Form C-103
Revised July 18, 2013

SUNDRY NOTICES AND REPORTS ON WELLS (DO NOT USE THIS FORM FOR PROPOSALS TO DRILL OR TO DEEPEN OR PLUG BACK TO A DIFFERENT RESERVOIR. USE "APPLICATION FOR PERMIT" (FORM C-101) FOR SUCH PROPOSALS.)	
1. Type of Well: Oil Well ☒ Gas Well ☐ Other	
2. Name of Operator EOG RESOURCES, INC	
3. Address of Operator P.O. Box 2267, Midland, TX 79706	
4. Well Location Unit Letter <u>G</u> : <u>1710</u> feet from the <u>North</u> line and <u>2310</u> feet from the <u>EAST</u> line Section <u>32</u> Township <u>20S</u> Range <u>33E</u> NMPM <u>Lea</u> County	
11. Elevation (Show whether DR, RKB, RT, GR, etc.) 3627'

EOG proposes to P&A this wellbore using the attached procedure. Current and Proposed wellbore schematics attached.

Hat Mesa State #3 P&A
Capital AFE# 184422

Proposed Wellbore Diagram:

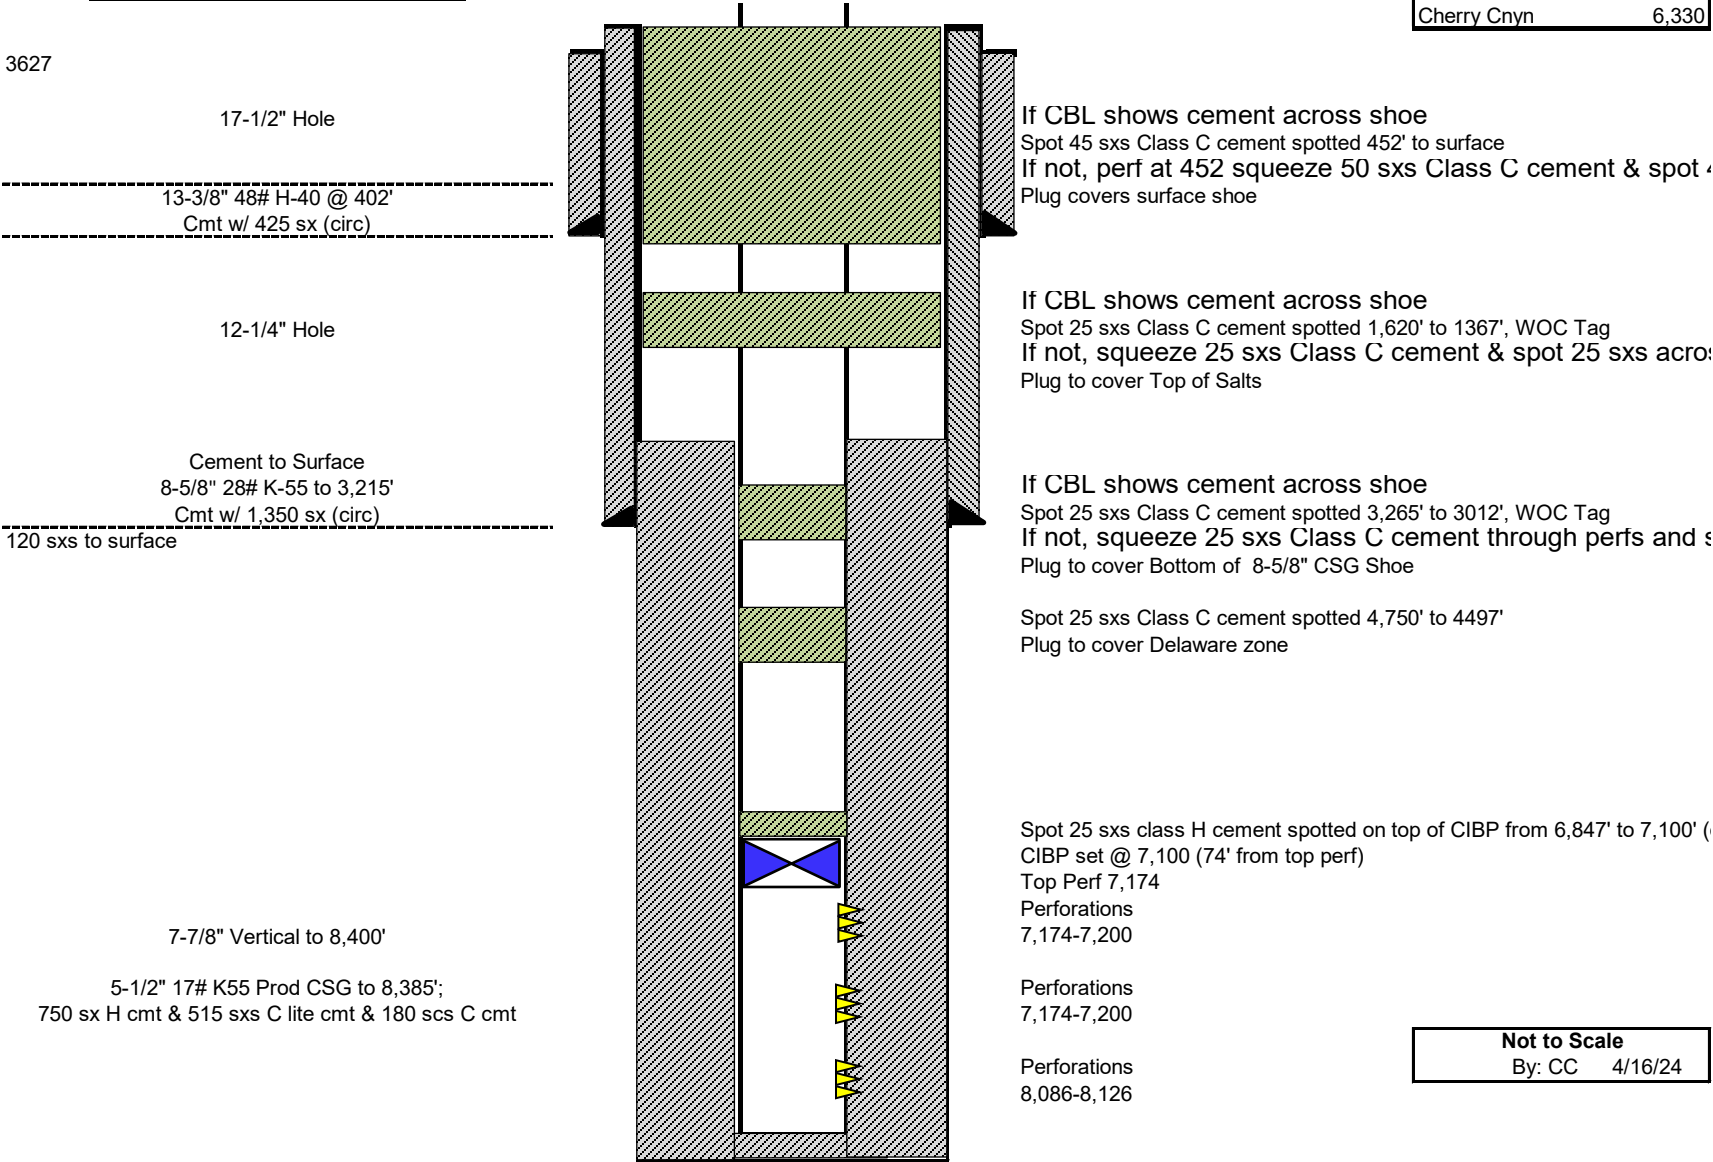
SEE CHANGES TO PROCEDURE

R-111-P Area

SEE ATTACHED COA's

MUST BE PLUGGED BY 5/1/25

Created By	Condition	Condition Date
gcordero	CBL must be submitted to OCD via OCD Permitting	5/7/2024
